March 20, 2023

Ms. Joan Lawrence, ASTM F15.22 Subcommittee Chair
Mr. Al Kaufman, ASTM F15.22 Task Group Chair
ASTM International
100 Barr Harbor Drive
West Conshohocken, PA 19428
jlawrence@toyassociation.org
akaufman@toyassociation.org

Figure 1. Example Product Packaging Warning Label

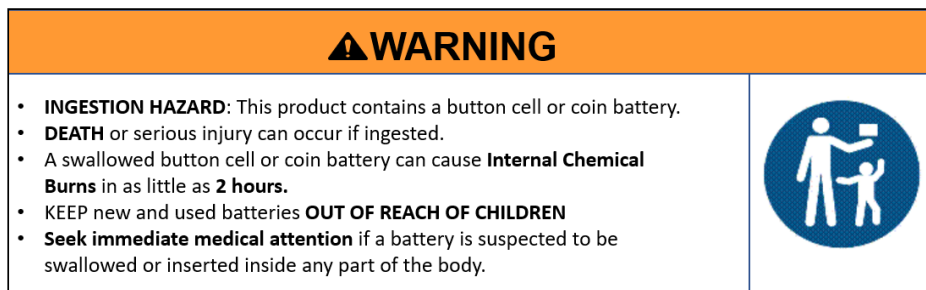
The NPR recommends specific warning labels for product packaging and products containing button cell or coin batteries. Examples of those labels are shown below. Staff asks the subcommittee to review the warning label and instructional literature requirements in the NPR, and to consider implementing similar warning label and instructional literature requirements for toy products containing button cell or coin batteries, to address the ingestion hazard.
